Go Ahead Ireland Bus Depot, Ballymount, Co. Dublin

Compliance Submission

Planning Reg No. SD21A/0213

Landscape Masterplan

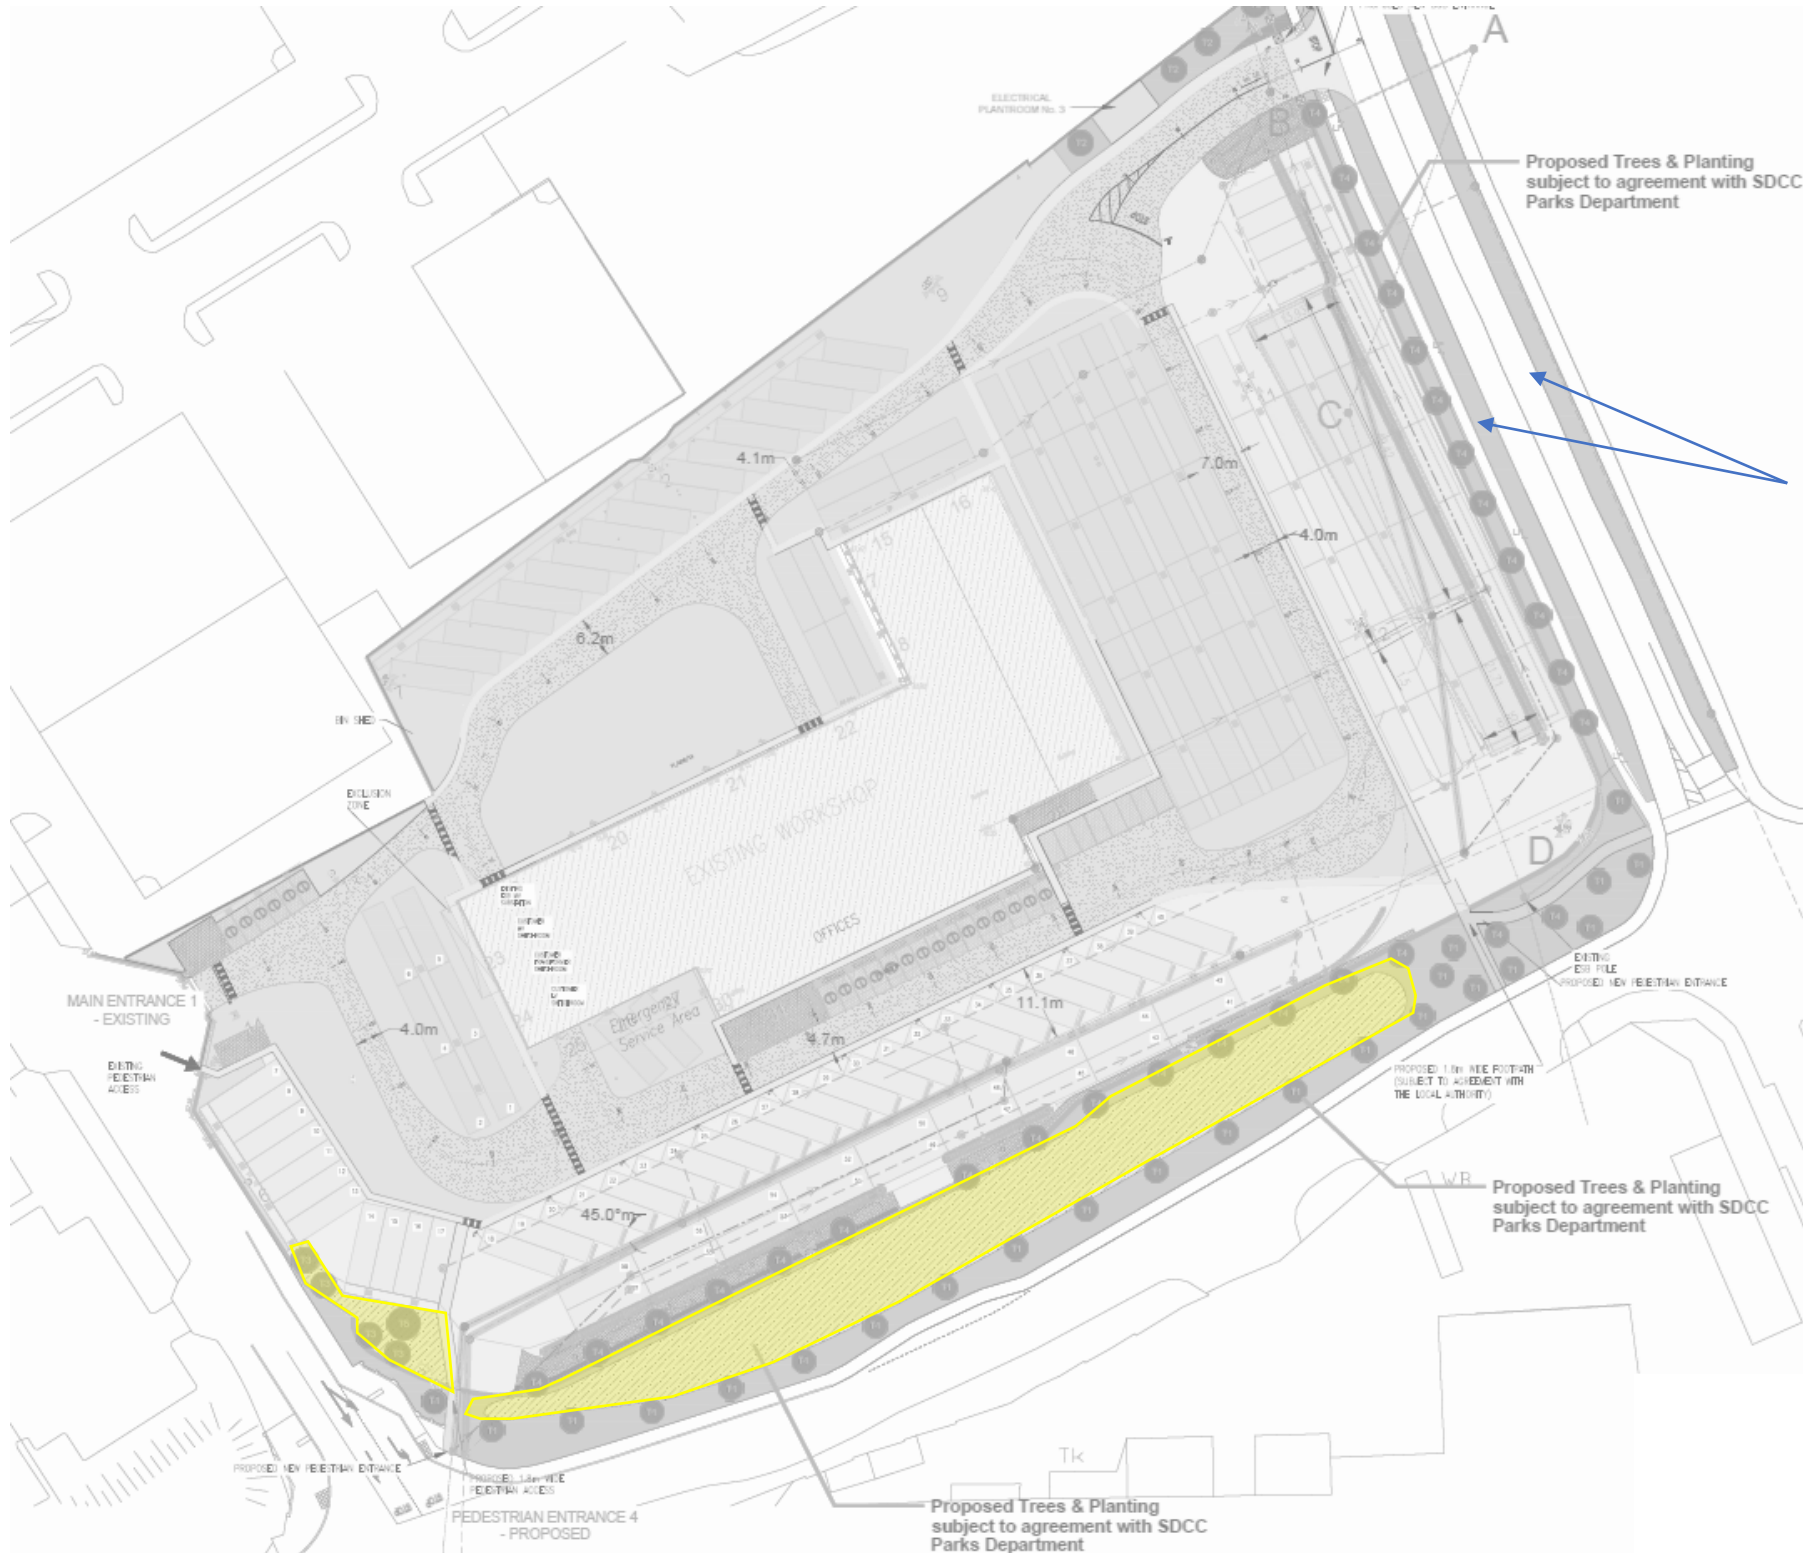
2 (a) Implementation of the Landscape Plans:

The Landscape Plan (Landscape Masterplan Drawings No. 1(A1) prepared by RMD) shall be implemented in full within the first planting season following completion of the development, in addition:

Wildflower Areas — proposed to retain existing naturalised grassland areas. No wildflower shall be sown

- Please find landscape masterplan DWG.01 – detailing all hard and soft landscape features
- The Landscape Plan shall be implemented in full within the first planting season following completion of the development. Landscape works shall be completed in full accordance with the approved Landscape Plan.
- All trees, shrubs and hedge plants supplied shall comply with the requirements of BS: 3936, Specification for Nursery Stock.
- All new tree plantings shall be positioned in accordance with the requirements of Table 3 of BS 5837: 2012 Trees in Relation to Design, Demolition and Construction. If any planting is damaged or diseased it will be replaced within an 18 month period.

Tree Planting – Outside the boundary

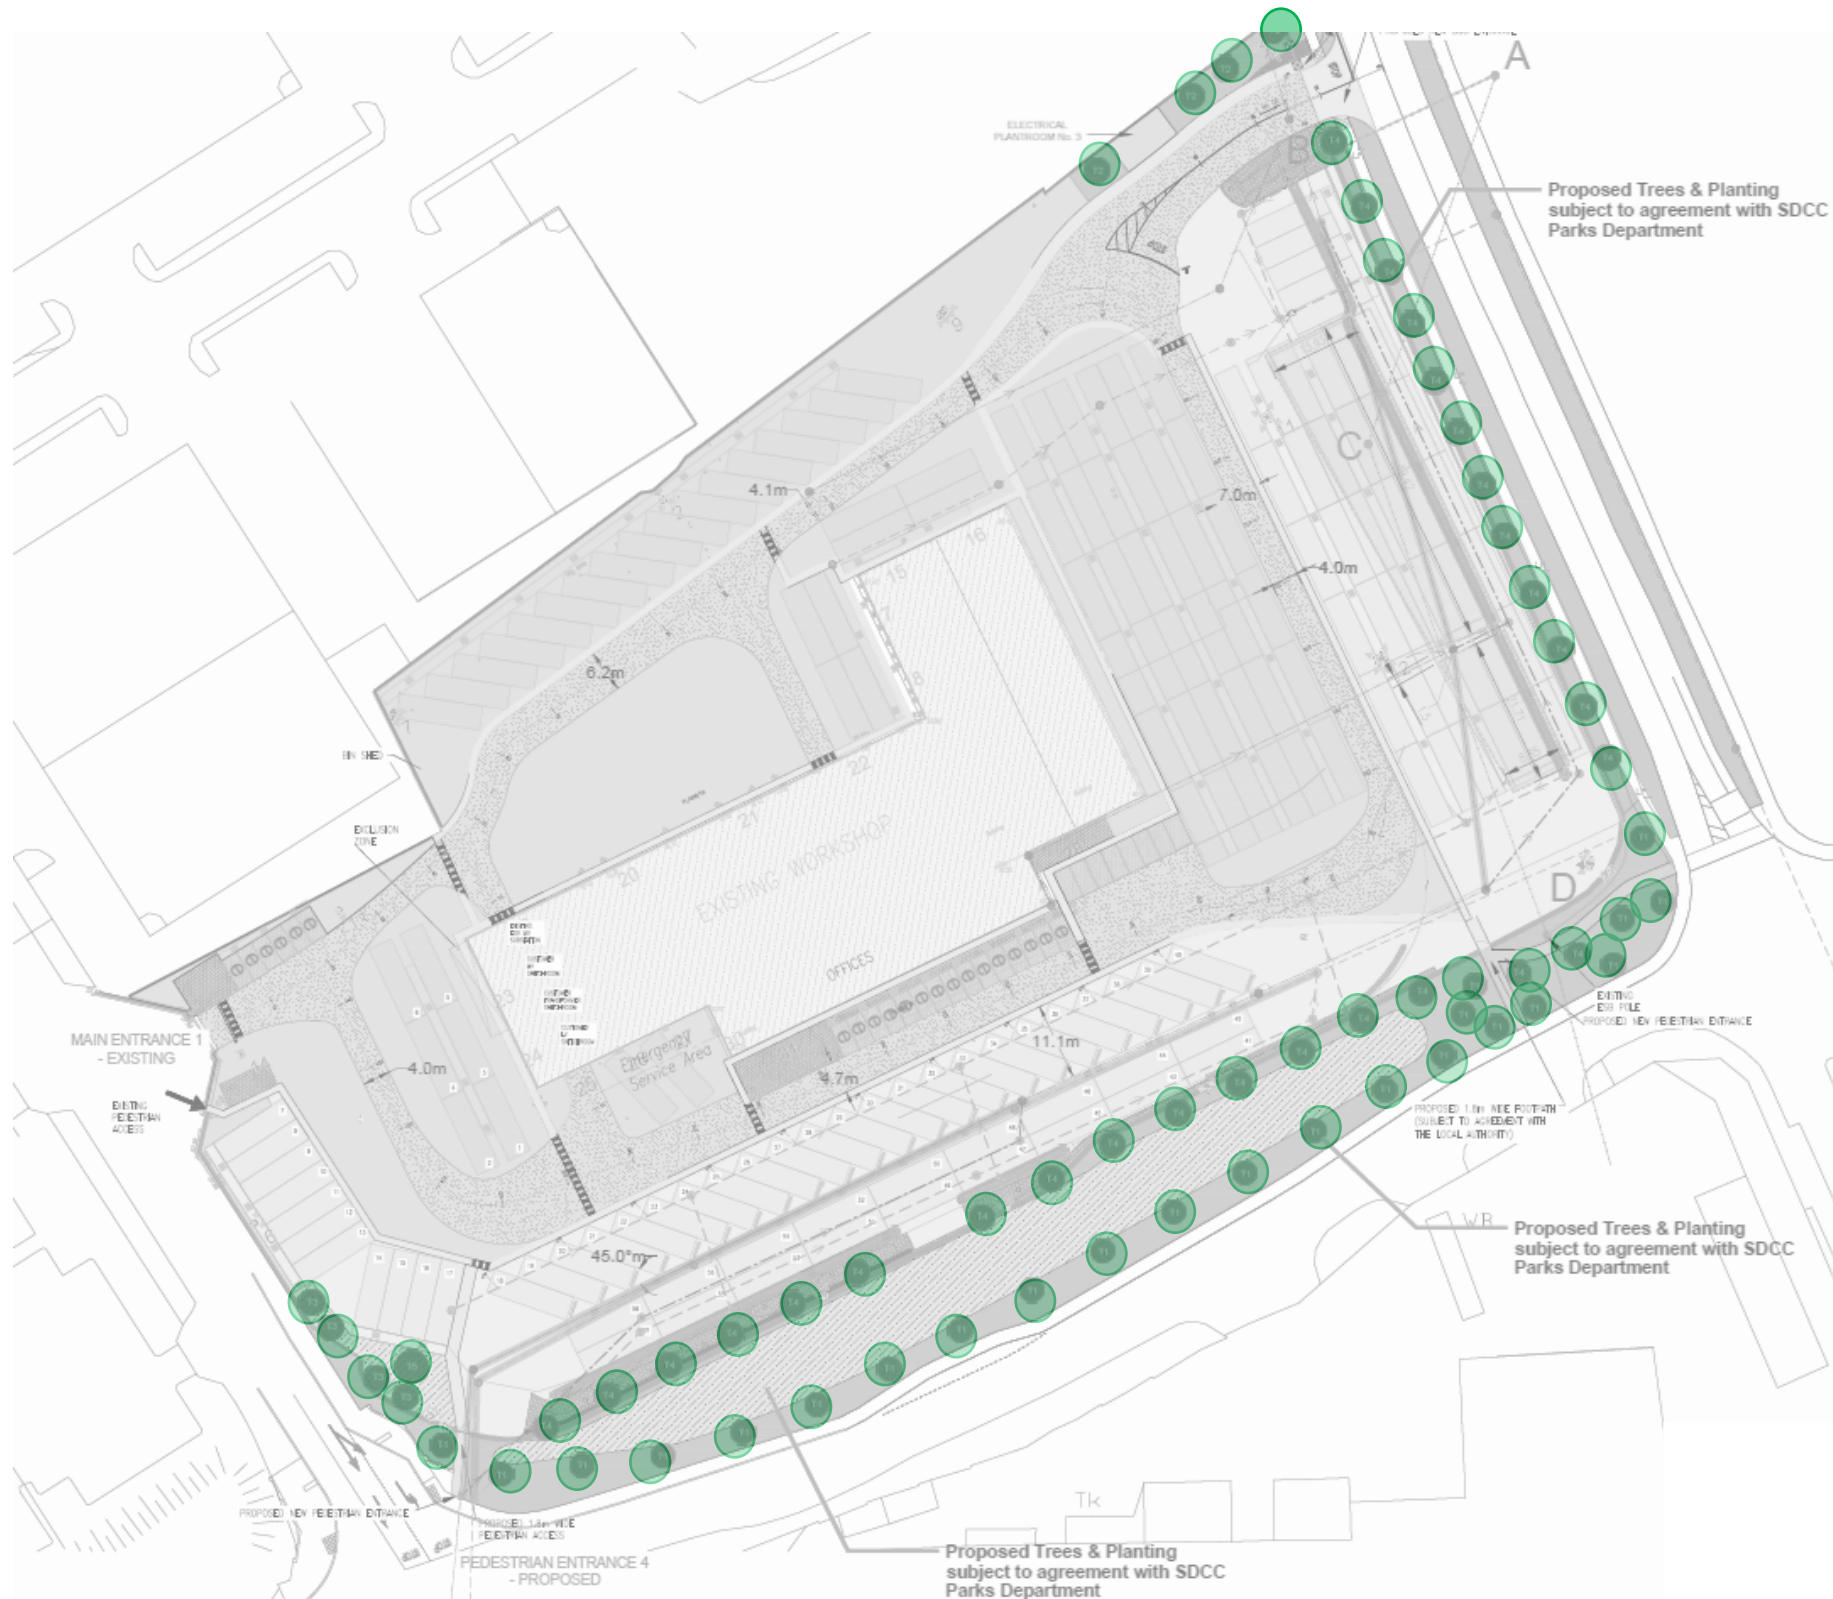
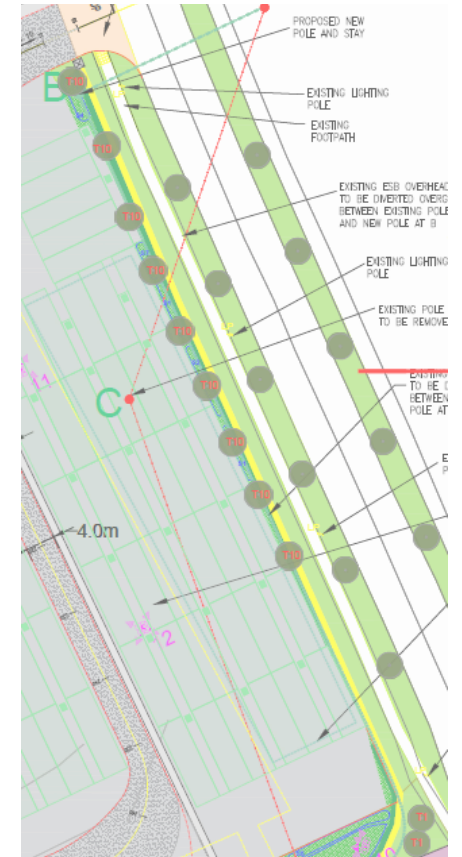
(d) Scheme for replacement trees/Compensatory Planting: Prior to the commencement of use of the development, details of replacement tree planting, indicating positions or density, species, and planting size shall be submitted to and approved by the Planning Authority. Planting shall take place in accordance with the approved details within the first planting season following completion of the development or in accordance with the program of planting approved by the Public Realm Section. Any such trees that are removed die or become, in the opinion of the Public Realm Section, seriously damaged or defective within a period of three years of planting shall be replaced with specimens of a similar size and species as originally required.

Original Planting Plan: - Before services drawing was updated

The margins have services in them. It is suggested to plant the trees in a revised location subject to agreement with SDCC.

Planting of trees in public realm is subject to agreement with SDCC public realm
